March 26, 2014

**RE: Public comments on the Lake George Marriot Hotel and Convention Center,
APA Project 2013-64**

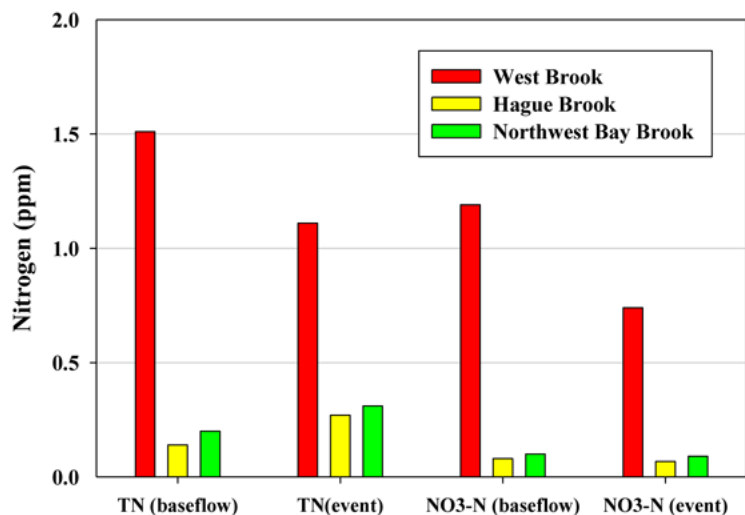
Capacity of Sewage Treatment Plant: There are many questions around the capacity of the Lake George municipal sewage treatment plant to handle the increased volumes from this facility. A recent study funded by the Department of State (DOS) looked at stream discharges to Lake George from around the lake. West Brook was found to be the biggest single source of nutrient loading to Lake George. West Brook loads at a significantly higher rate than other streams in the basin.

One thing that sets West Brook apart is that the sewage treatment plant leaches nutrients into it through the groundwater. West Brook is downslope from the sewage treatment plant, about 1/3 of a mile away. The study funded by the DOS (and the APA should make sure that they get this compete study) is based on multiple samples from West Brook at natural locations on the flanks of Prospect Mountain west of the Northway and then downstream in the Village before and after ground water leaching points from the sewage treatment plant.

Concentrations of Total Nitrogen and Nitrate, 2007-2010

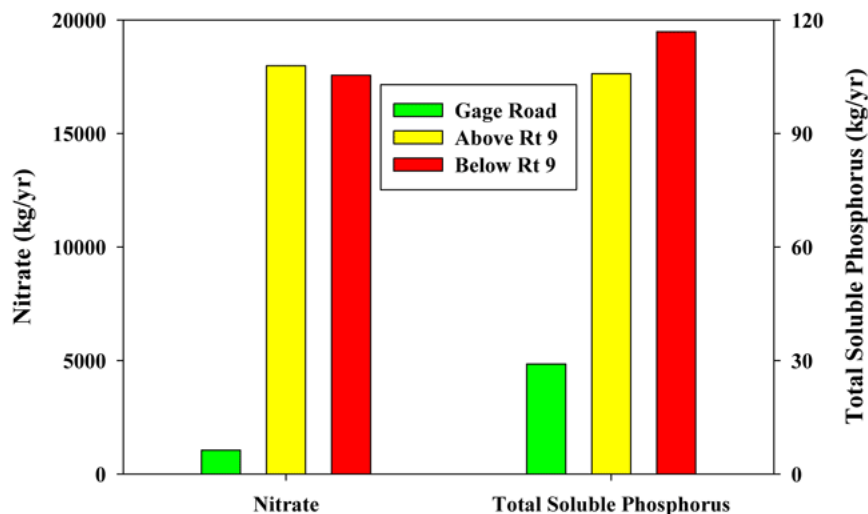
The Total Nitrogen chart shows a major difference in water quality between West Brook and other major streams around Lake George. The charts above shows the significant difference in water quality in West Brook above and below the point where the sewage treatment plant leaches into West Brook through ground water. The difference in water quality upstream and downstream from the sewage plant is undeniable.
